Product Change Note

Change of Raspberry Pi 3A+ PCB to Revision 2.

Raspberry Pi 3A+ devices

Image identification

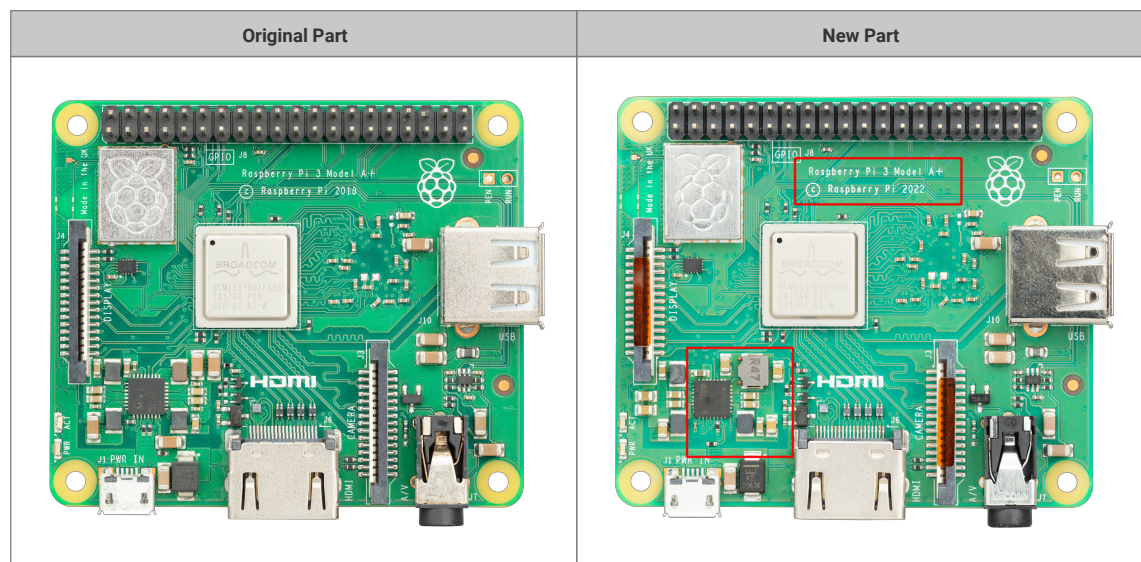
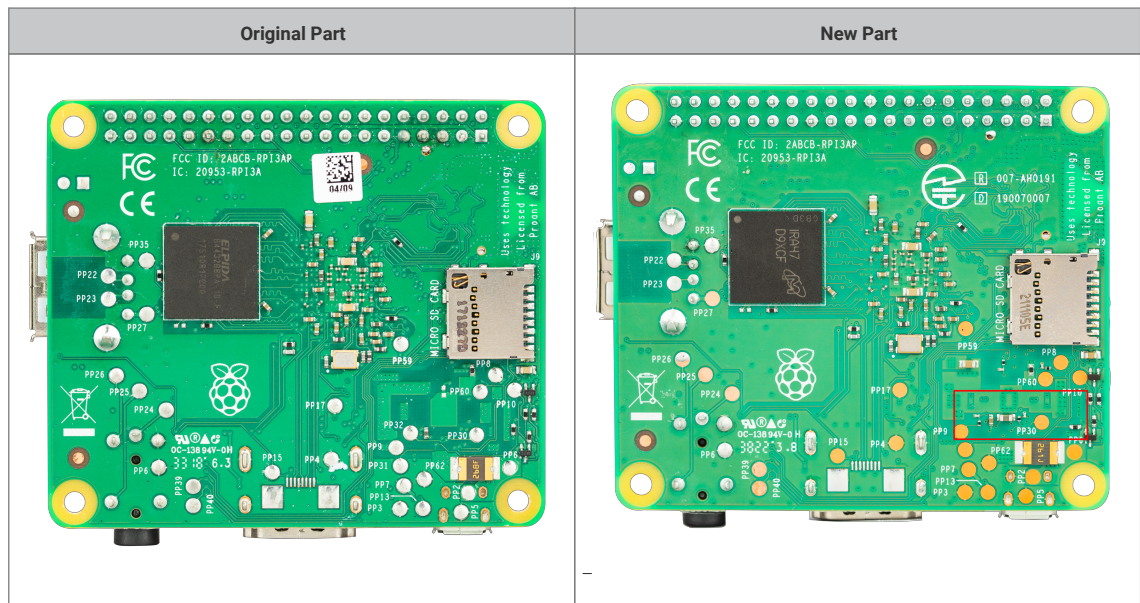
Identification Method to Distinguish Change

New product can be distinguished by:

- `cat /proc/cpuinfo` will report "Model" as "Raspberry Pi 3 Model A Plus Rev 1.1"
